INNER WEST COUNCIL	
DEVELOPMENT ASSESSMENT REPORT	
Application No.	201500736.01
Address	43-51 Addison Road, Marrickville
Proposal	Application under Section 82A of the Environmental Planning and Assessment Act to review Determination No.201500736, dated 21 November 2016, to demolish the existing industrial buildings and construct a 4 storey motel with a café/restaurant and basement parking.
Date of Lodgement	14 February 2017
Applicant	GAT & Associates
Owner	Vince Perry
Number of Submissions	62
Value of works	\$7,490,000
Reason for determination at Planning Panel	The officer's recommendation under the S82A review involves no substantial change to the prior determination.
Main Issues	Demolition of existing building, architectural expression/streetscape presentation, building height variation and calculation of gross floor area.
Recommendation	Refusal

1. Executive Summary

2. Review Request

AREA SCHEDULE:

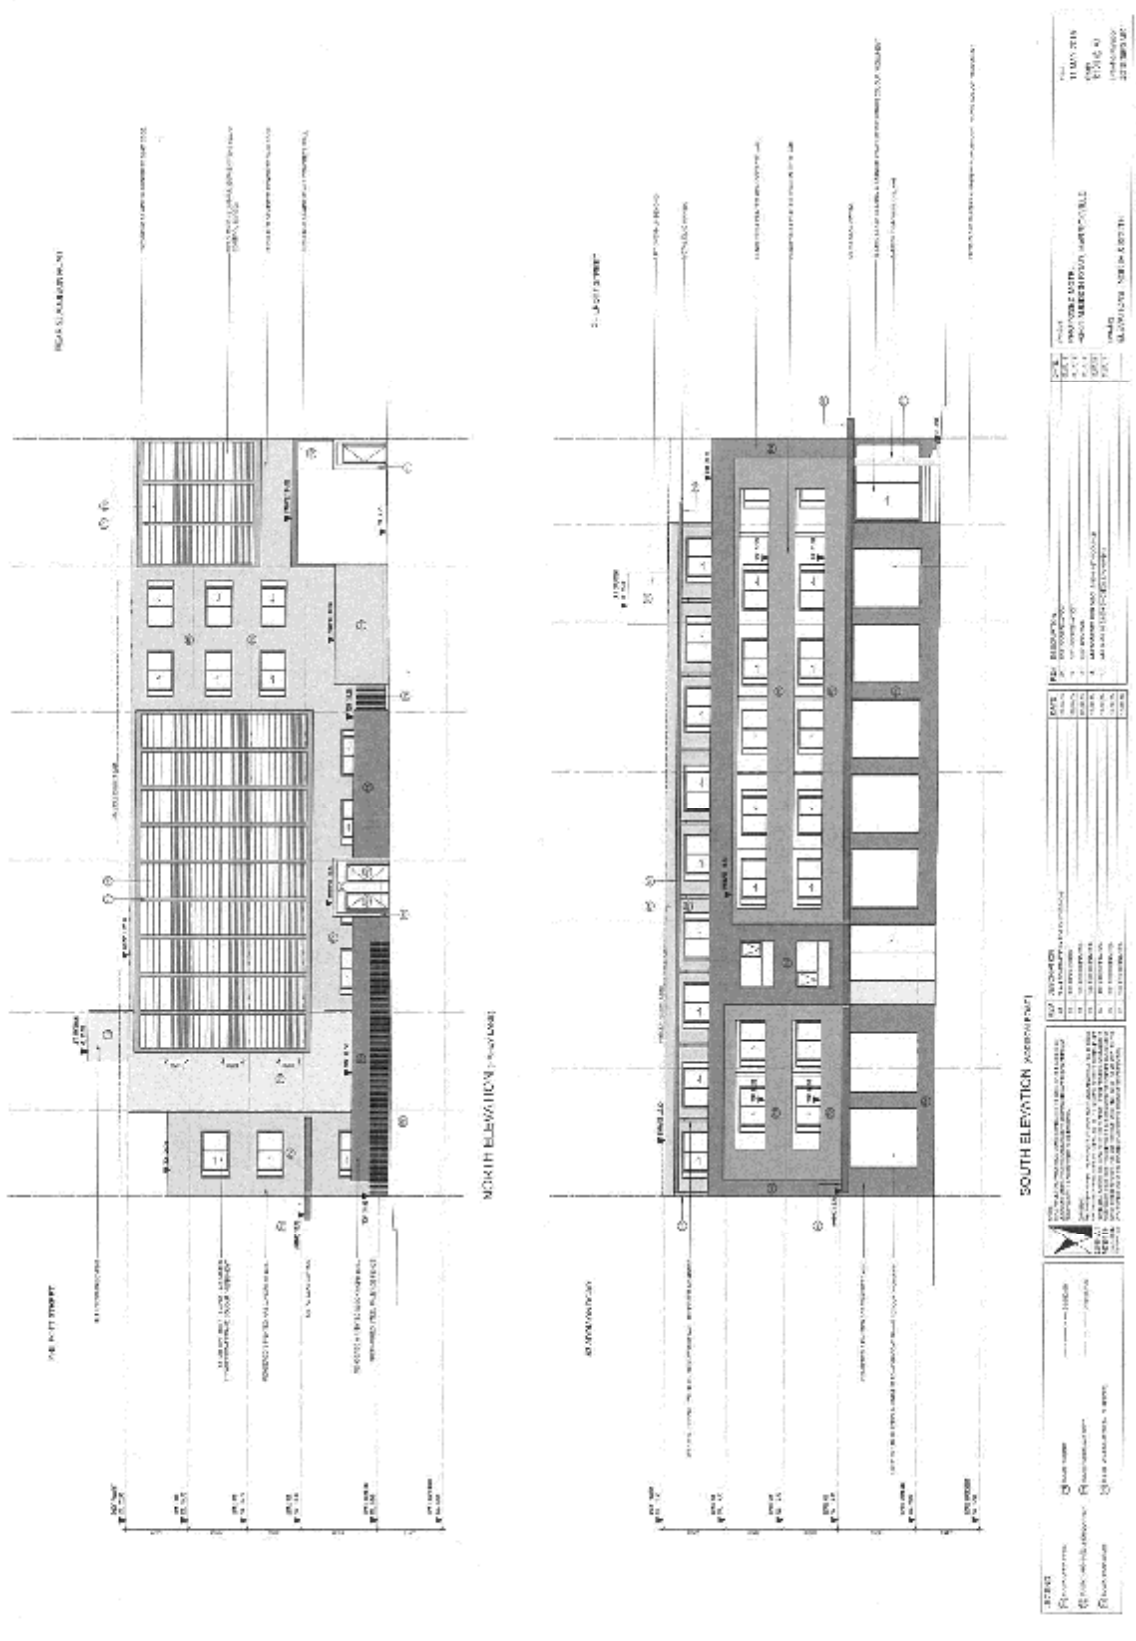
The site has a maximum allowable FSR of 1.75:1 (2087.75m²). The amended plans were accompanied by shaded gross floor area (GFA) diagrams which claim that the proposed development has an FSR of 1.74:1 (2077.5m²). However, the method of calculating GFA is not agreed with. This is because the applicant's calculations exclude the 25m² garbage room proposed adjacent to the lane at the rear of the site. It is noted that the garbage room does not contain a roof but is enclosed by walls that are approximately 2.9m high and is therefore required to be included in the FSR calculation in accordance with the definition of *gross floor area* in MLEP 2011. Inclusion of the garbage room would result in a 14.75m² FSR breach.

It is arguable that the north facing balconies with external screening should also be included in the calculation of gross floor area as they are largely enclosed, which would further increase the extent of the breach. Inclusion of the screened balconies would increase the extent of the FSR breach to approximately 106m².

Project PROPOSED MOTEL 43-61 ADDISON ROAD, MARRICKVILLE FOR VINCE FERRY	Date 11 MAY 2015
Drawing PERSPECTIVES	Drawing Number 20/538/DATE01

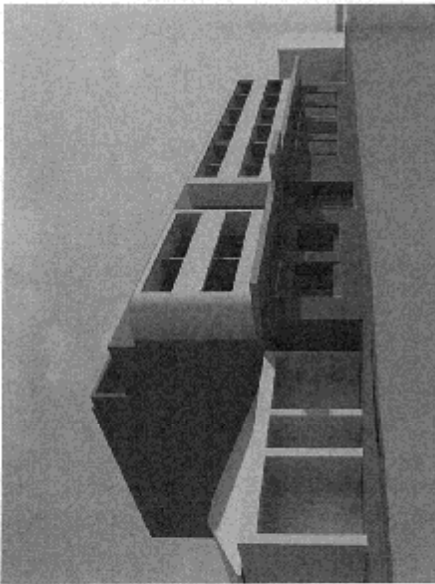
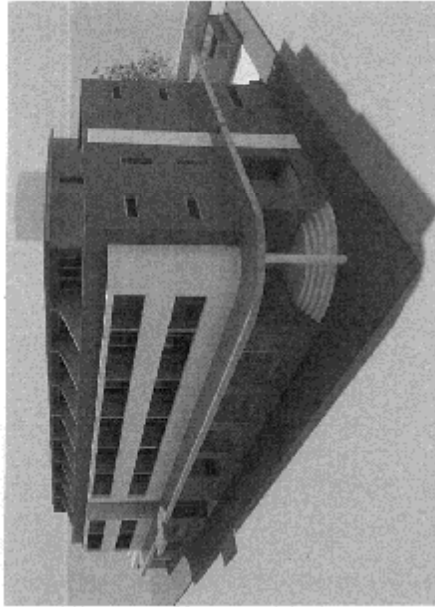
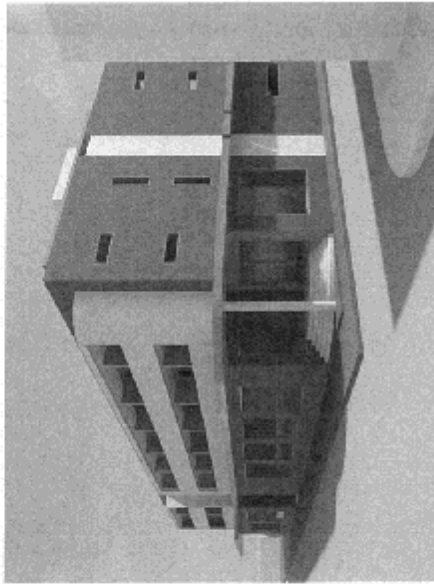
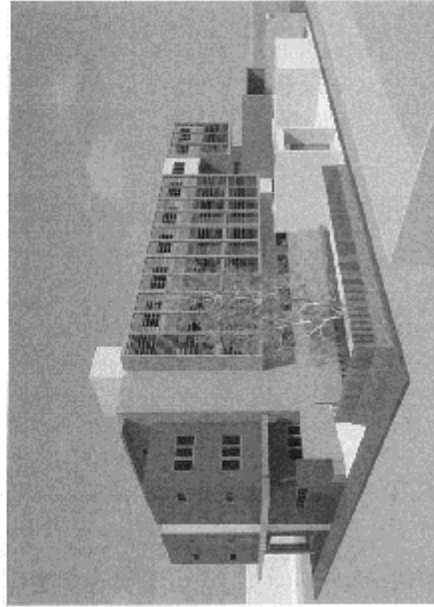
The east elevation and floor plans depict 2 windows on Level 01 and 2 windows on Level 02, whereas the perspective drawings appear to show 3 windows on each of these levels. See Image 3 and 4 below:
